Safety Notice – powerCON TRUE 1

Date: 4th July 2018
Author: Thomas Walker
Product: Tessera XD

powerCON TRUE1

Product Change Notification

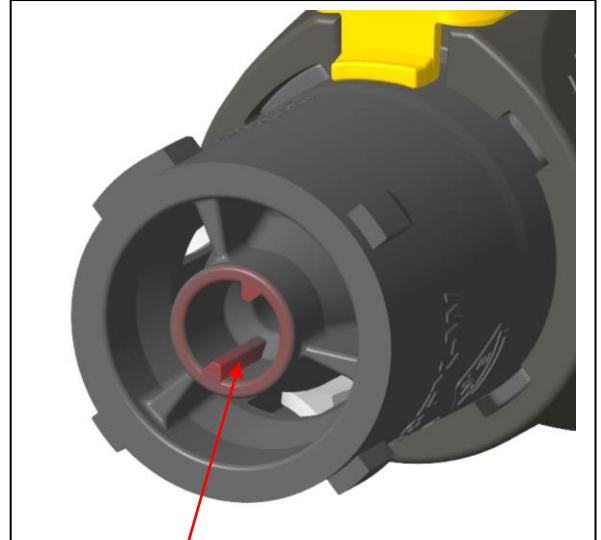
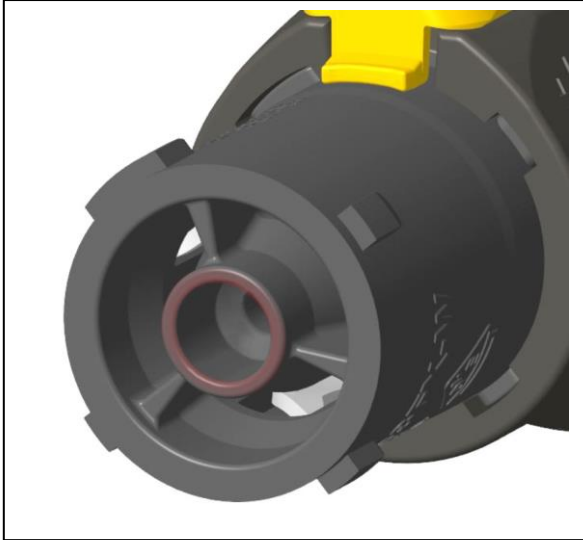
Current Version

Modified Version

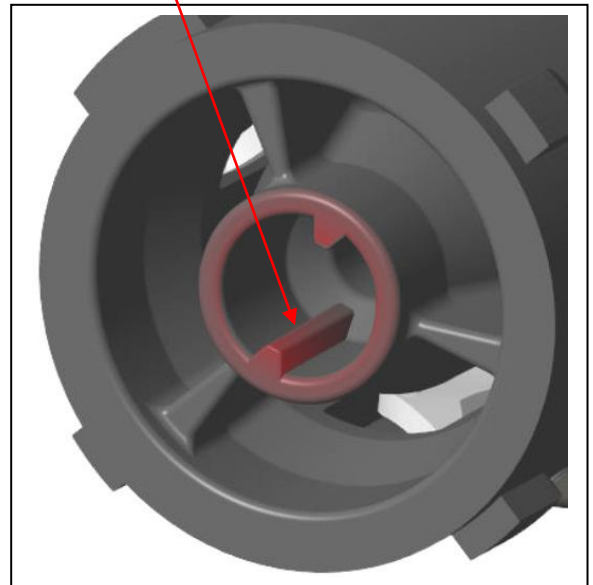
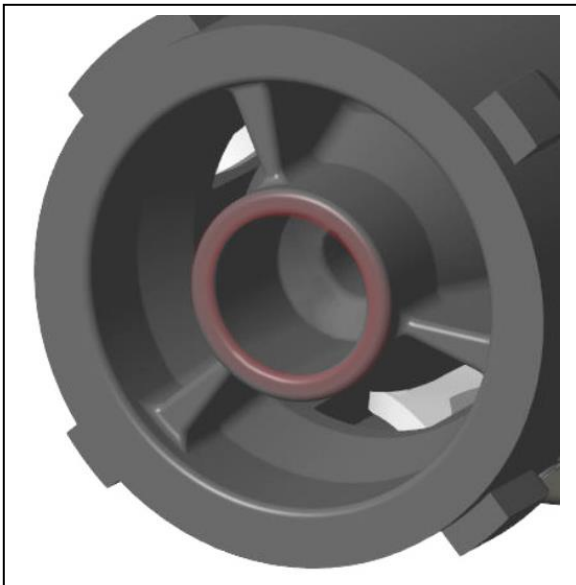
Modification on appliance inlet NAC3MPX:

Enlargement of center stopper

Modification on cable connector NAC3FX-W:

additional ribs

Wrong insertion by 90°:

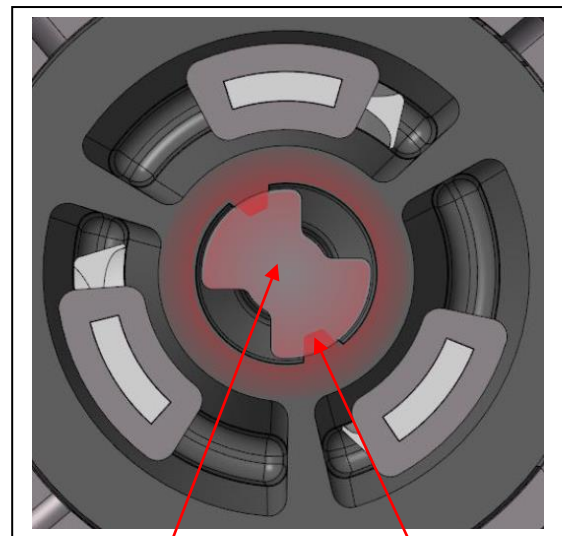
center stopper does block insertion by the ribs

In the case of wrong insertion the additional ribs run up the stopper and prevent full insertion thus contacting is avoided.
